**ALAMEDA COUNTY COMMUNITY DEVELOPMENT AGENCY
PLANNING DEPARTMENT**

2ND ADDENDUM TO PRIOR STAFF REPORTS

APPLICATION: CONDITIONAL USE PERMIT, PLN2014-00056

PROPOSAL: To approve the Summit Wind Repower Project, to redevelop an existing wind farm through replacement of up to 569 older wind turbines with up to 31 new approximately 2.1 megawatt (MW) turbines, resulting in a maximum capacity of roughly 54 MW, and adding new technology and infrastructure.

FIGURE 15
TURBINES IN RELATION
TO BRUSHY PEAK SUMMIT

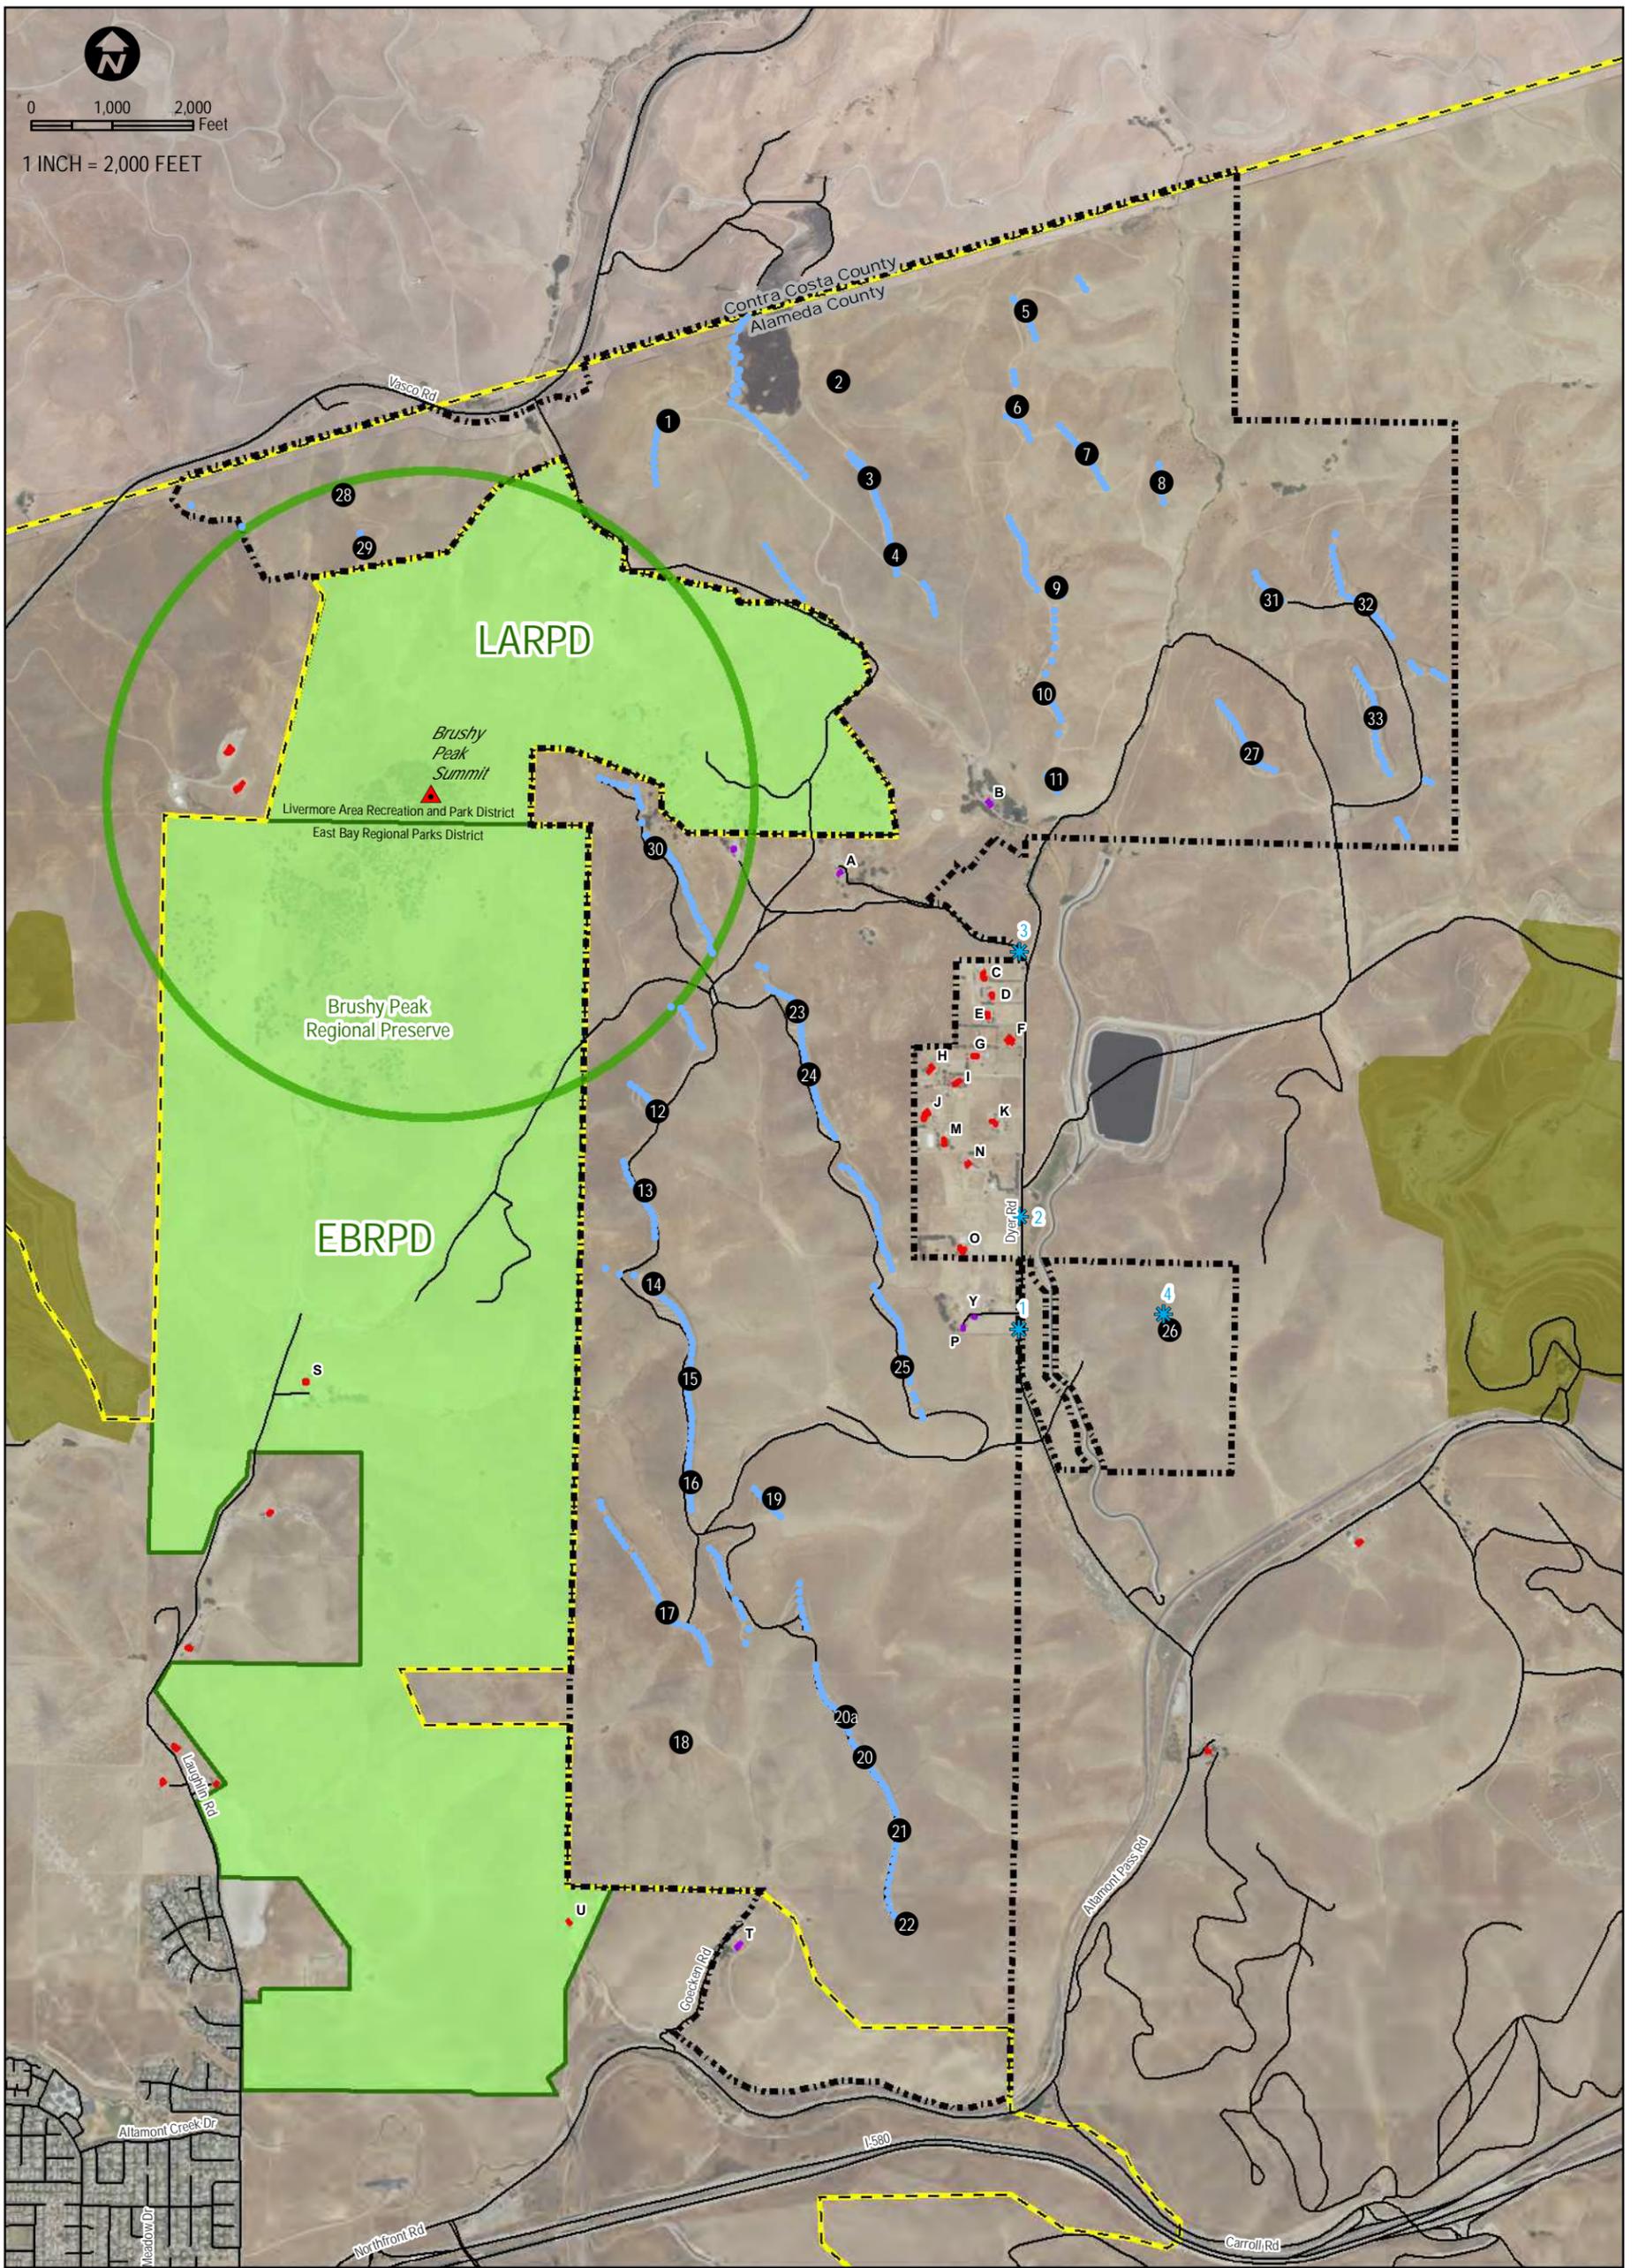
In response to public comments received and by direction of the East BZA Board, Figure 15 was prepared to show the location of individual homes as well as a 4,000-foot radius buffer around the Brushy Peak summit in the Brushy Peak Regional Preserve. Three turbines (28, 29 and 30) were proposed within this buffer; however, following the November 19th hearing, Altamont Winds and Park District representatives met on December 2, 2015. As a result of this meeting and discussions occurring between the applicant and the Park District, Altamont Winds LLC has agreed to no longer pursue development of turbines 29 and 30.

- **Summit Repower Wind Project – Blade Throw Analysis**

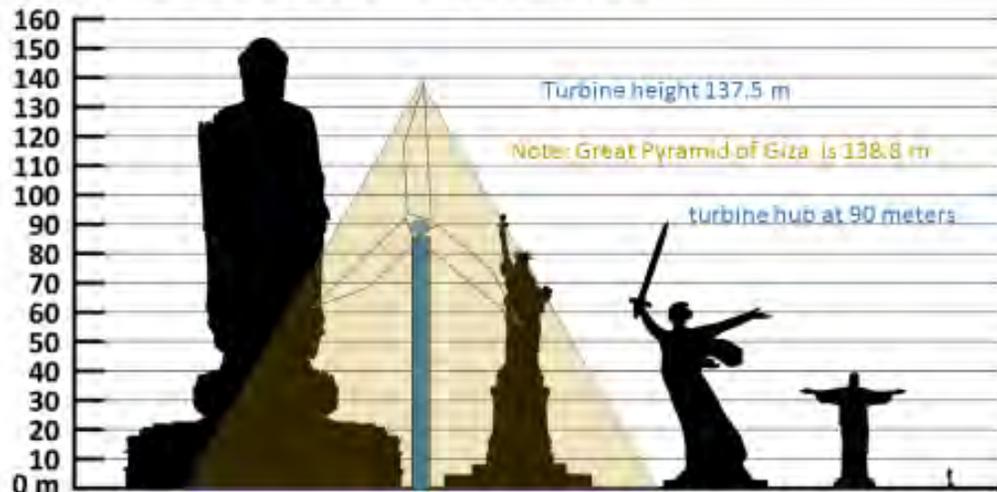
- It is unclear why the distance to a PGE line is used as a standard.
- The house near Turbine 25 is approximately 224 meters from the turbine and sits right at the edge of the shaded circle indicating the blade throw distance.
